THE PHARAOH'S SUBDIVISION

Engineering Comments: FINAL PLAT COMMENTS (should be addressed prior to submitting the FINAL PLAT for review and/or signature by the City Engineer):

APPLICATION NUMBER 2 DATE August 1, 2019

DETAIL SITE PLAN

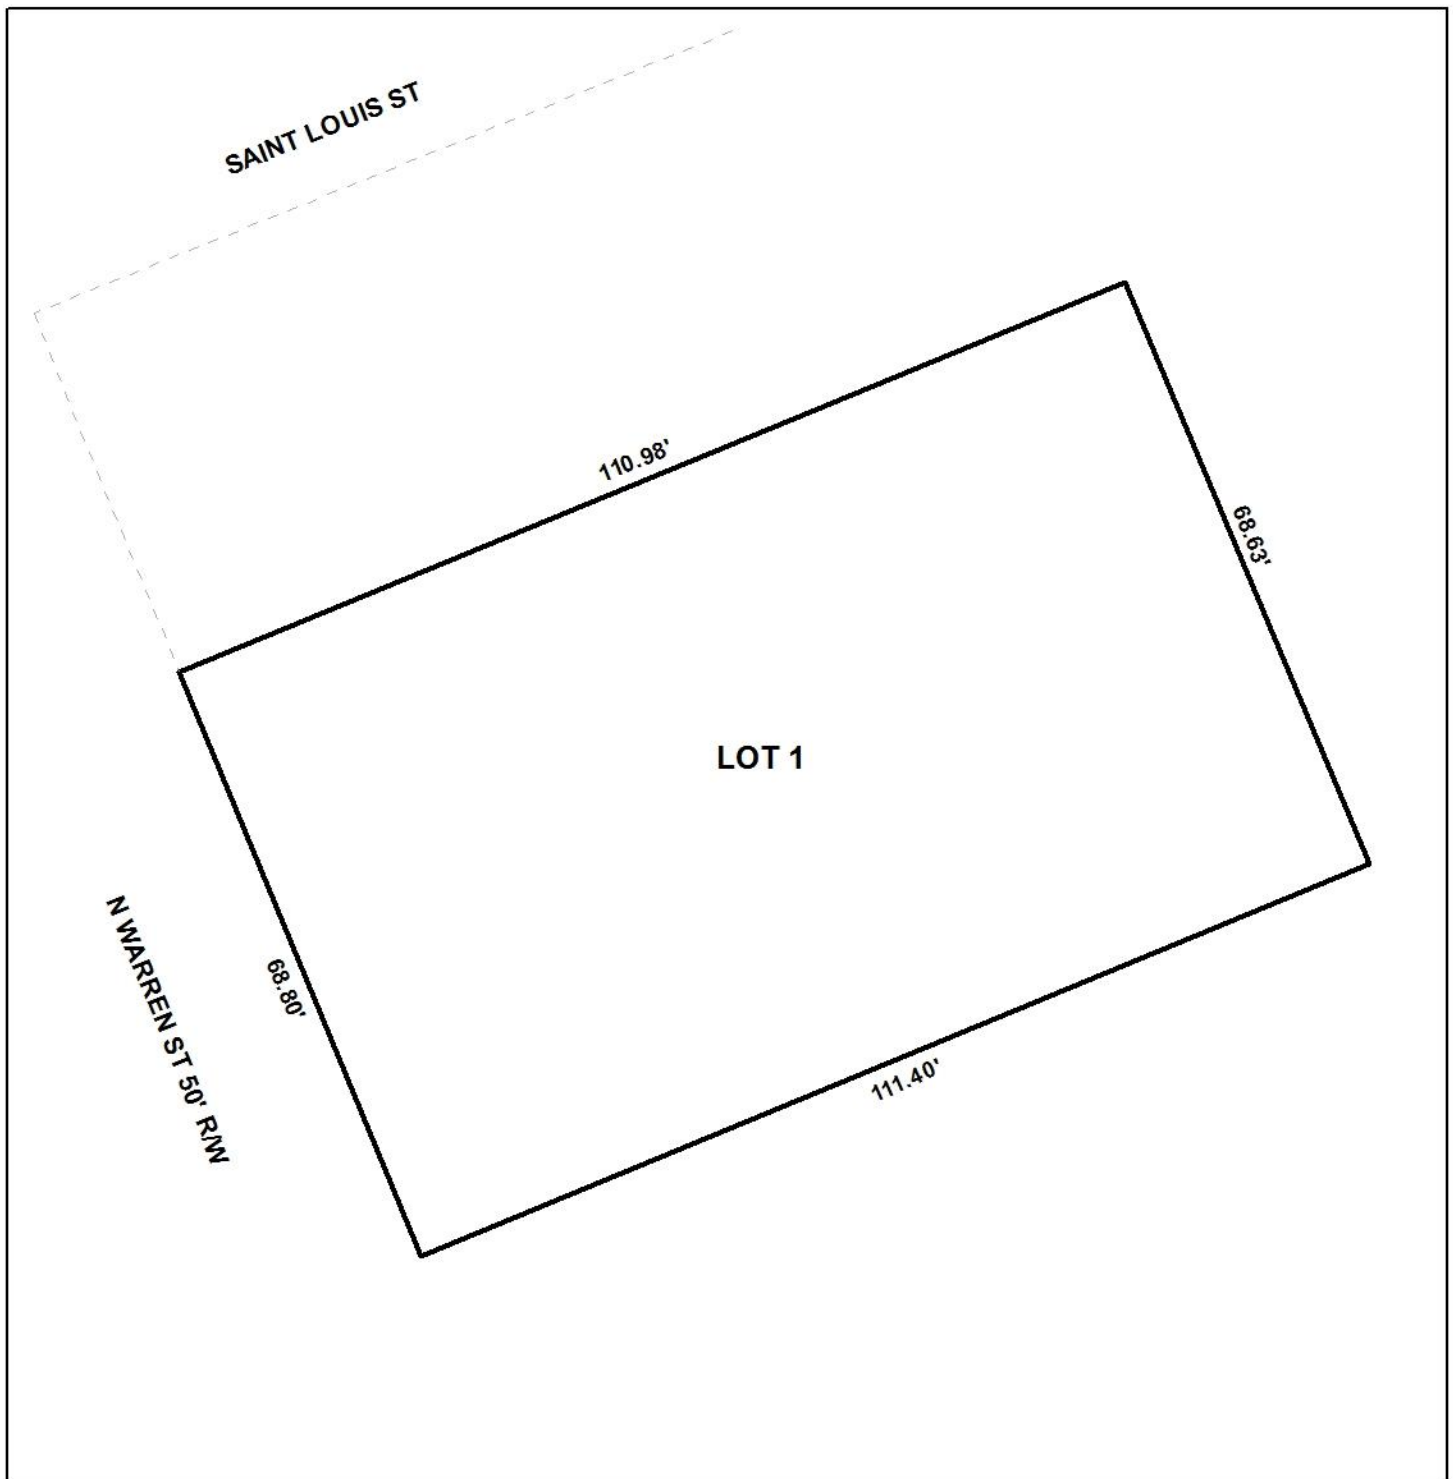
- B. Show and label the POC and POB.
- C. Show and label the MFFE (Minimum Finished Floor Elevation).
- D. Show and label the contours as indicated in the note.

The proposed subdivision fronts North Warren Street. A 50' right-of-way width is illustrated on the preliminary plat for North Warren Street and, if approved, should be retained on the Final Plat.

There are no building setback lines illustrated on the preliminary plat. The DDD, per Section 64-3.1.8.(d), allows from 0' minimum to 10' maximum setback along all street frontages. If approved, the Final Plat should be revised to illustrate a 10' maximum building setback line along the street frontage, with a note stating a 0' minimum is allowed.

The proposed lot does not meet the 7,200 square foot minimum lot size requirements of Section V.D.2. of the Subdivision Regulations for lots served by public water and sanitary sewer systems. The preliminary plat provides the lot sizes in square feet and in acres. If approved, the

lot size information should be retained in both square feet and acres on the Final Plat. However, it should be noted that there is no minimum lot area requirement for lots within the DDD.

- 1) Retention of the 50' right-of-way width to North Warren Street;
- 2) Illustration of a 10' maximum building setback line along the street frontage, with a note stating that 0' minimum building setback is allowed;

- 3) Retention of lot size information in both square feet and acres;
- 4) Compliance with Engineering comments: (*FINAL PLAT COMMENTS* (should be addressed prior to submitting the FINAL PLAT for review and/or signature by the City Engineer): A. Provide all of the required information on the SUBDIVISION PLAT (i.e. signature blocks, signatures, certification statements, written legal description, required notes, legend, scale, bearings and distances) that is required by the current Alabama State Board of Licensure for Professional Engineers and Land Surveyors. B. Show and label the POC and POB. C. Show and label the MFFE (Minimum Finished Floor Elevation). D. Show and label the contours as indicated in the note. E. Provide the Surveyor's, Owner's (notarized), Planning Commission, and Traffic Engineering signatures. F. Add a note to the SUBDIVISION PLAT stating that a Land Disturbance permit will be required for any land disturbing activity in accordance with Mobile City Code, Chapter 17, Storm Water Management and Flood Control); the City of Mobile, Alabama Flood Plain Management Plan (1984); and, the Rules For Erosion and Sedimentation Control and Storm Water Runoff Control. G. Add a note to the Plat stating that the approval of all applicable federal, state, and local agencies (including all storm water runoff, wetland and floodplain requirements) will be required prior to the issuance of a Land Disturbance permit. H. Add a note that sidewalk is required to be constructed, and/or repaired, along the frontage of each lot, or parcel, at time of new development or construction, unless a sidewalk waiver is approved. I. Add a note to the plat stating that all easements shall remain in effect until vacated through the proper Vacation process. J. Provide a copy of the FINAL SUBDIVISION PLAT to the Engineering Dept. for review. No signatures are required on this drawing. K. After addressing all of the FINAL SUBDIVISION PLAT review comments by the Engineering Dept. provide the red-line markup, the ORIGINAL (with all other signatures) and one (1) copy of the revised original (signatures not required) of the revised Final Plat to the Engineering Department.);
